SERVICE INSTRUCTION

INCREASE OF DISK SPRING PRE-TENSION IN THE GEARBOX ON ROTAX[®] ENGINE TYPE 912 AND 914 (SERIES)

SI-912-015

SI-914-018

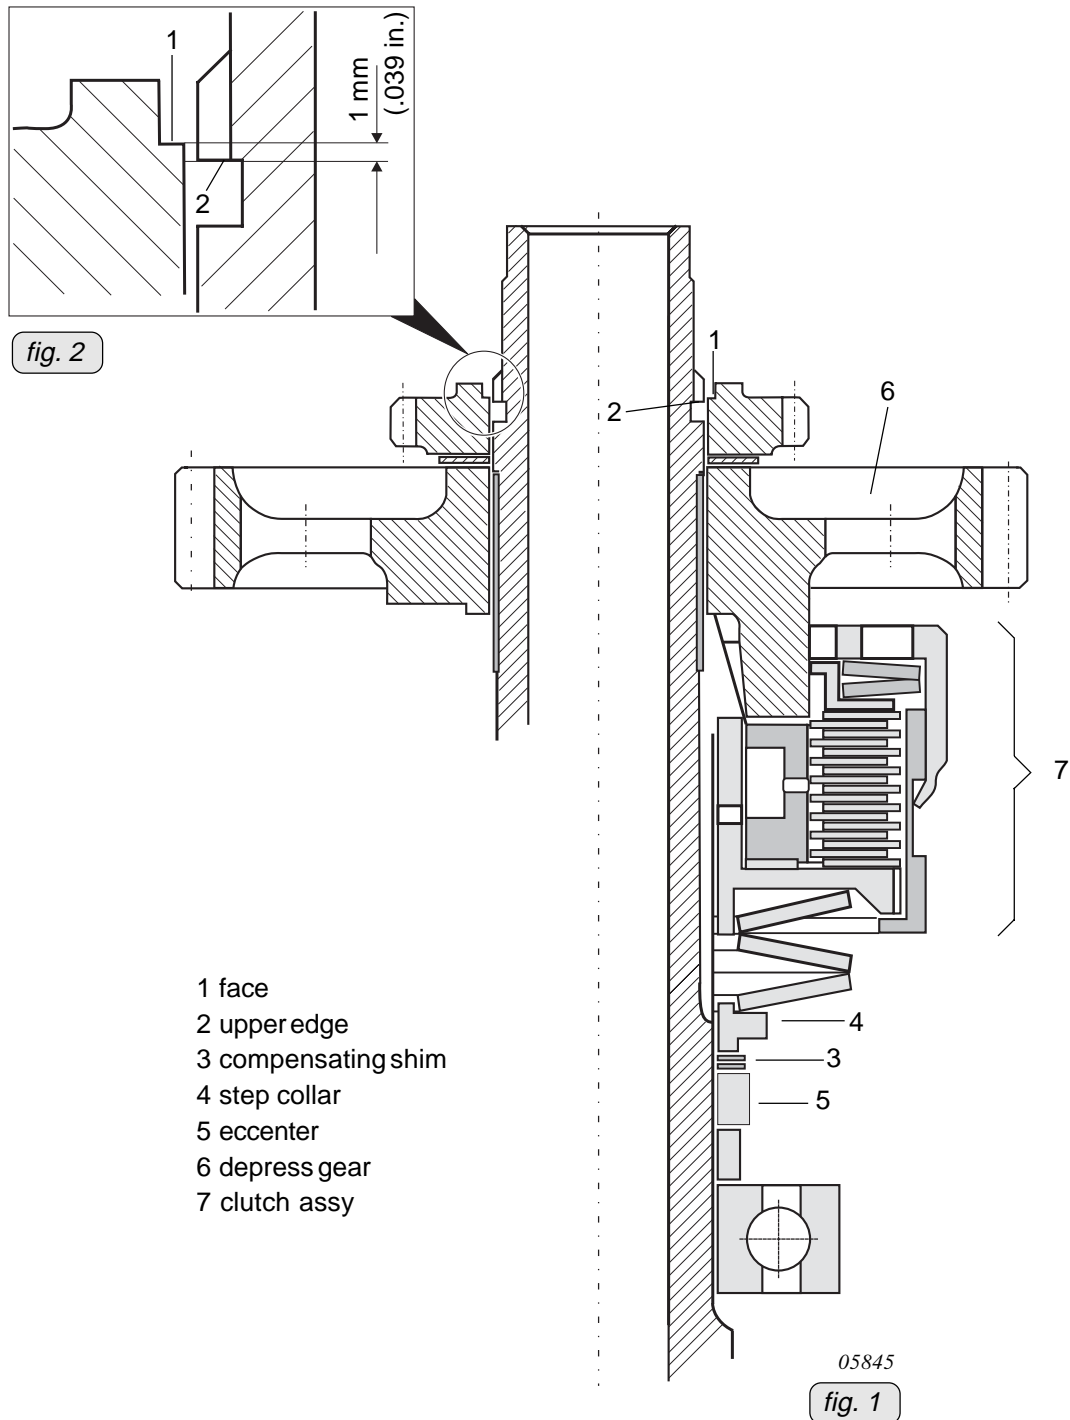
With springs in the released state, the face (1) for the ring half must be **1 mm (.039 in.)** over the upper edge (2) of the groove in propeller shaft. Adjust by inserting shims (3) placed without fail between eccentric (5) and step collar (4).

◆ **NOTE:** Due to the difficulty in making the described measurement, it possible to shim the assembly to align the face of the ring half (1) with the upper edge of the groove (2) and then add a 1mm shim (3) between the step colar (4) and the eccentric (5).

After setting the above value, depress gear (6) with assembly tool, until the ring halves can be inserted. Insert ring halves. Release disk springs. For all works see also the relevant Maintenance Manual.

■ **CAUTION:** Never depress springs flat with a too short alignment, otherwise the dog gear will damage the gear cover!

■ **CAUTION:** The ring halves must be completely inserted in the groove on propeller shaft!

Due to extension of the disk-spring pre-tension the friction torque of the dog connection has being changed. The friction torque must be min. 25 Nm to max. 60 Nm (220 to 530 in. lb.). See also the relevant Maintenance Manual except the new specified ficition value.
